City of Detroit
Inter-Departmental Communication

RE: Petition #248
Request to Convert to Easement The East/West In the block Bound Ferry,
Brush, Kirby, John R.

NOTICE OF PROPOSED CHANGE IN PROPERTY

B						CONVERSION TO EASEMENT THE EAST/WEST PUBLIC ALLEY, VARIOUS WIDTHS IN THE BLOCK BOUND BY FERRY, KIRBY AVE., BRUSH AND JOHN R. ST.	CITY OF DETROIT CITY ENGINEERING DEPARTMENT SURVEY BUREAU
A							JOB NO. 01-01
DESCRIPTION		DRWN	CHKD	APPD	DATE		DRWG. NO. X 248
REVISIONS							
DRAWN BY	WLW	CHECKED		KSM			
DATE	05-23-18	APPROVED

PETITION NO. 248
 COLLEGE FOR CREATIVE STUDIES
 C/O CLARK HILL
 500 WOODWARD AVE. SUITE 3500
 DETROIT, MICHIGAN 48226
 C/O EMILY BALDWIN
 PHONE NO. 313 965-8300

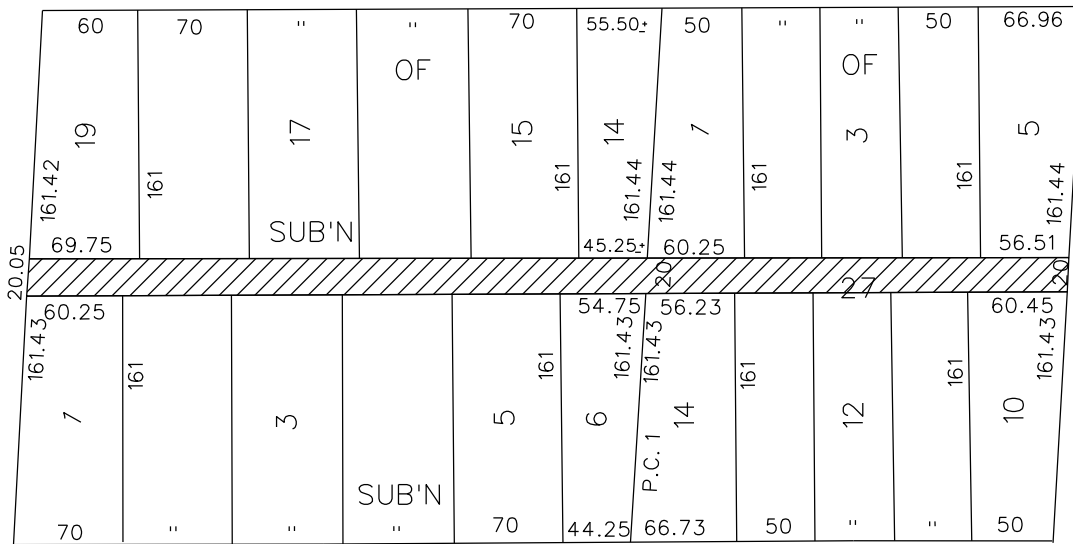
- Our records indicate that there is a sewer in the alley. DWSD has no objections to the conversion to easement provided that the attached provisions for conversion to easement are followed.

1. An easement, the full width of the existing right of way, is reserved for the Detroit Water and Sewerage Department for the purpose of installing, maintaining, repairing, removing, or replacing any sewers, water mains, fire hydrants and appurtenances, with the right of ingress and egress at any time to, and over said easement for the purpose above set forth.
